CASE NO. FP-2025-0034
ORDER OF CONDITIONAL
APPROVAL OF FINAL PLAT

HEARING DATE: 02/10/2026
TO: Mayor & City Council
FROM: Nick Napoli, Associate Planner
nnapoli@meridiancity.org
SUBJECT: Apex Northwest No. 7
FP-2025-0034
LOCATION: Near the northwest corner of S. Locust Grove Rd. & E. Lake Hazel Rd., in the E ½ of the SE ¼ of Section 31, Township 3N., Range 1E.

Final Plat consisting of sixty-four (64) single family building lots and eleven (11) common lots on 20.667 acres of land in the R-8 zoning district for the Apex Northwest Subdivision No. 7. Alternative Compliance to the pathway landscaping requirements in UDC 11-3B-12 for landscaping in the Williams Pipeline easement.

APEX NORTHWEST SUBDIVISION NO. 7
 MERIDIAN, ID
 COMMON DRIVE EXHIBIT
 BLOCK 15 LOTS 33-37

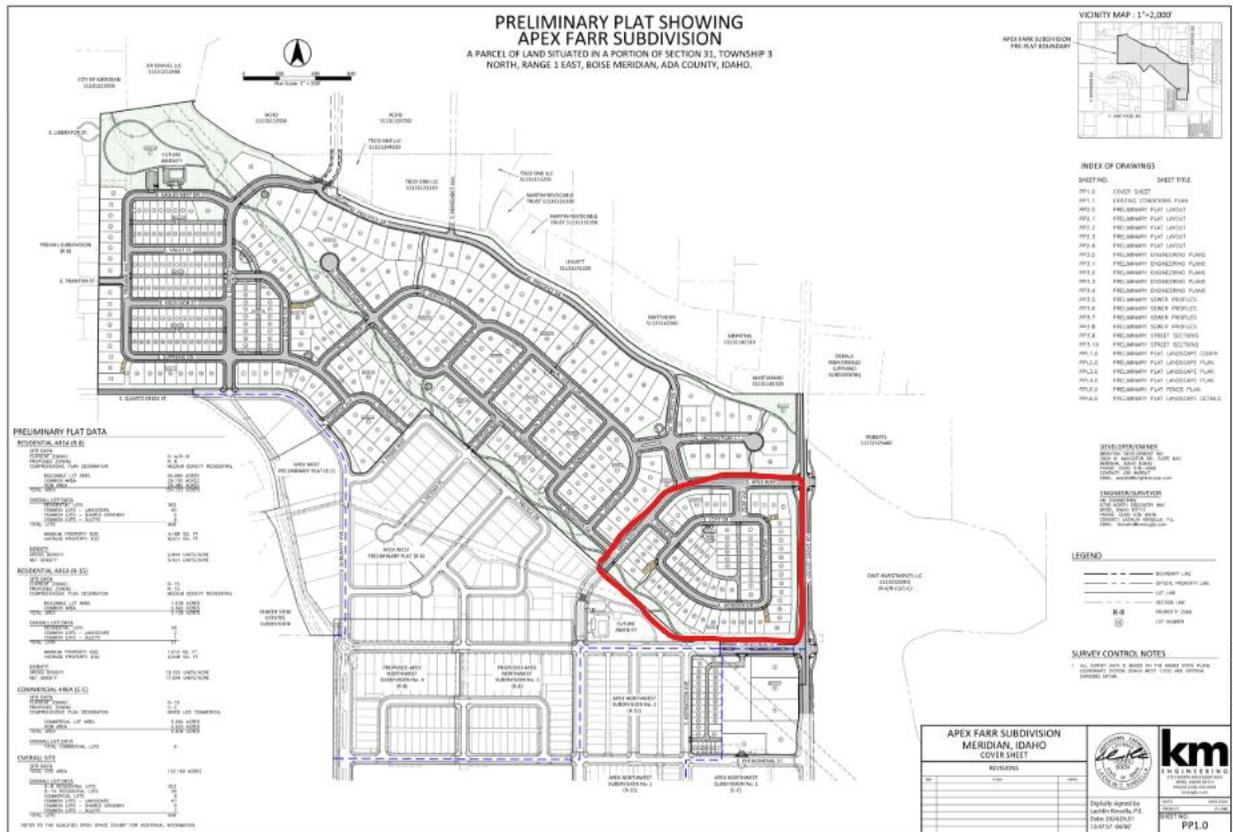
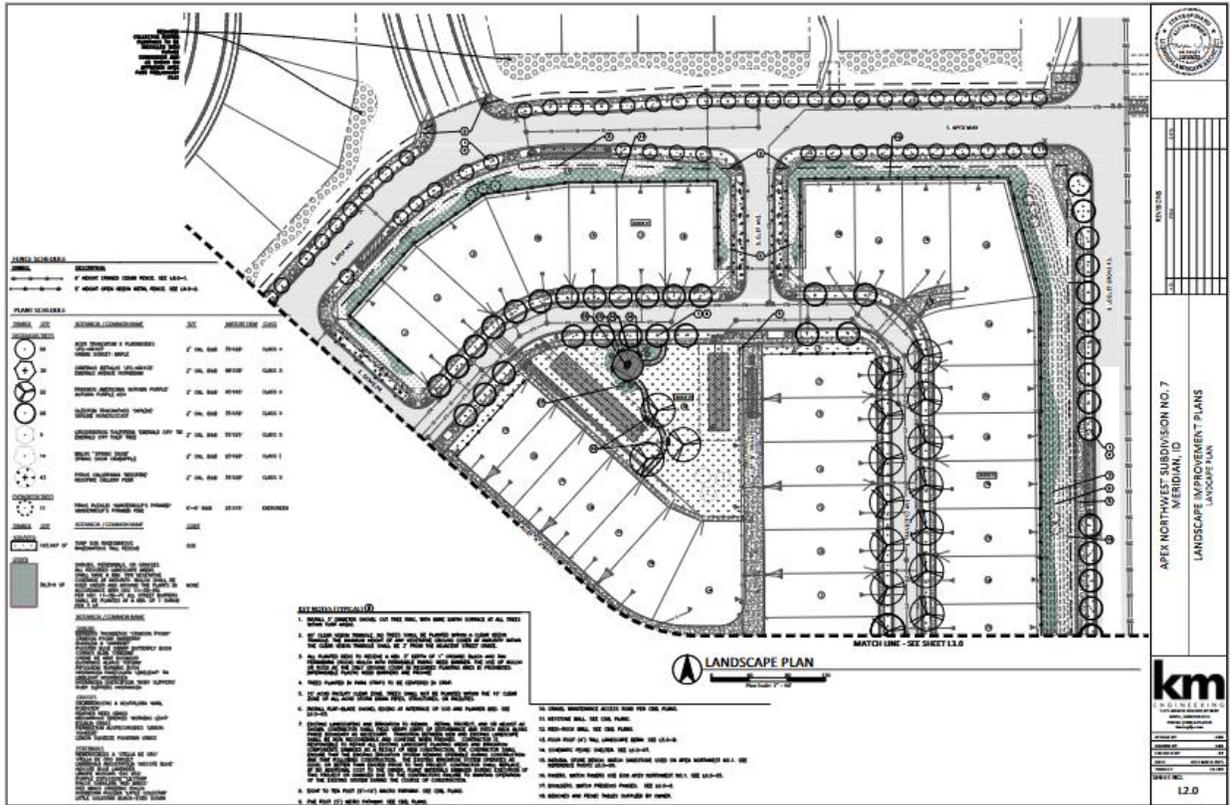
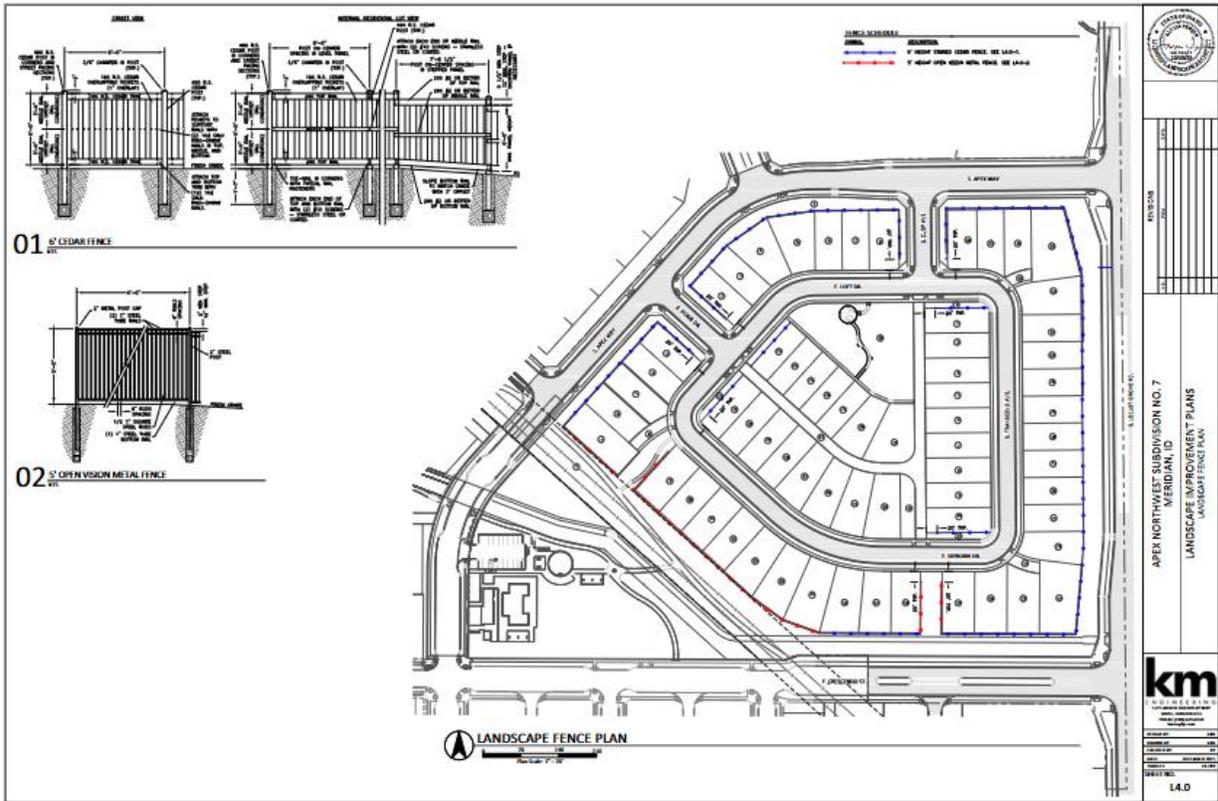
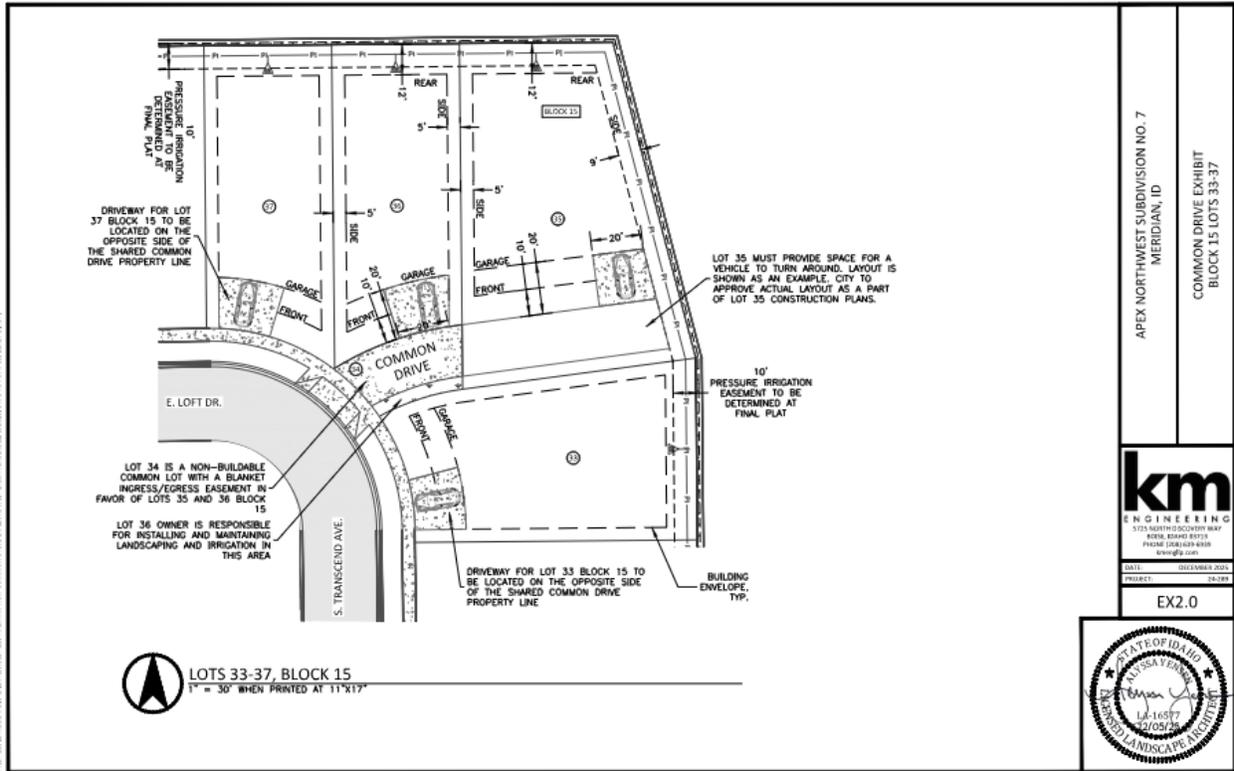
12. The applicant shall comply with the common drive standards in UDC 11-6C-3C and the exhibits included with this application. In addition, the applicant shall install no parking signs along the common drives in the required 5-foot landscape strip.
